Model: Whale 3rd Roll Feeder		Date: 30-Nov-97	No: 01
Modified Article: Side Plates		Prepared by: A. Sasaki	
From: QAC Field Information Dept.			
Reason for Modification:	<input type="checkbox"/> Parts catalog correction <input type="checkbox"/> Vendor change <input type="checkbox"/> To meet standards		
	<input type="checkbox"/> To facilitate assembly <input checked="" type="checkbox"/> To improve reliability ()		
	<input type="checkbox"/> Part standardization <input type="checkbox"/> Other

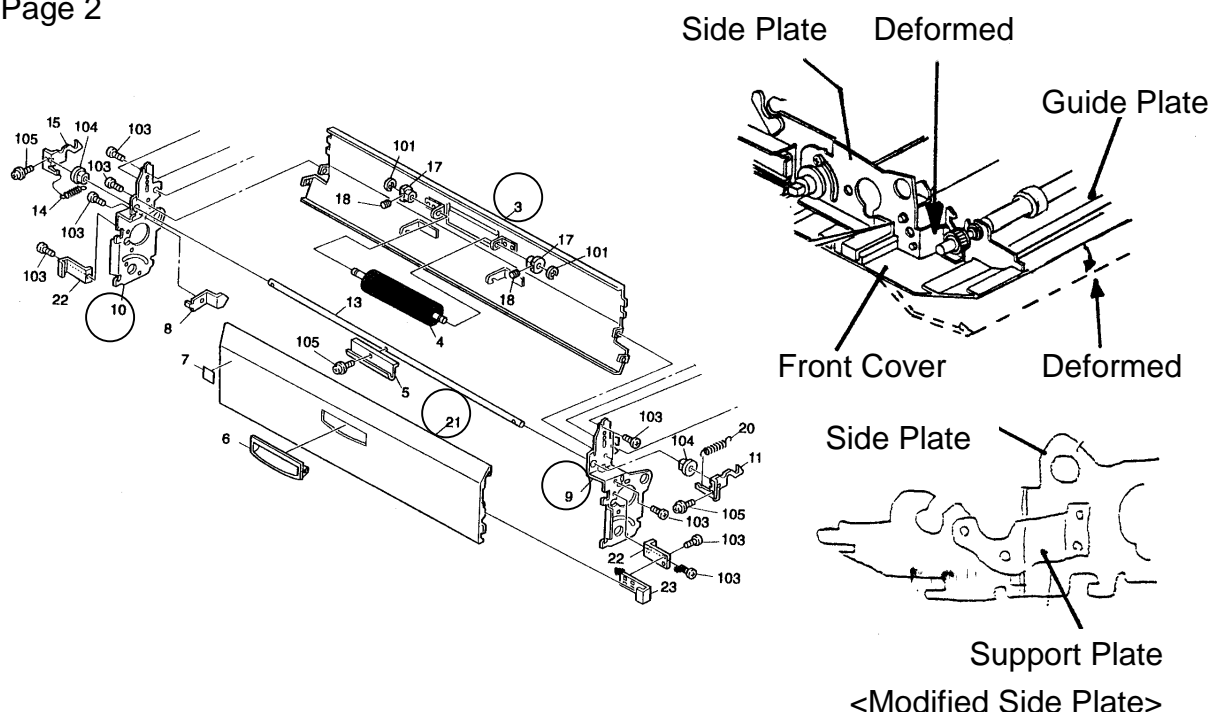
Old part number	New part number	Description	Qty	Int	Page	Index	Note
A6132551	A6132547	Right Side Plate	1	X/O	3	9	(*1)
A6132550	A6132546	Left Side Plate	1	X/O	3	10	(*1)

If a large pressure, like when a roll of paper is dropped, is applied to the front cover (Index 21) of the 3rd Roll Feeder when it is opened, the right and left side plates (Index 9 and 10) may become deformed. The guide plate (Index 3), which is in the paper path, is deformed towards the front side. This increases the width of the paper path. This may cause paper jams at the entrance of the cutter unit.

(*1) These parts can be replaced individually but please replace both of them at the same time to make them more effective.

A support plate has been added to the right and left side plates to make them stronger by 10 kgf each (20 kgf for both sides combined).
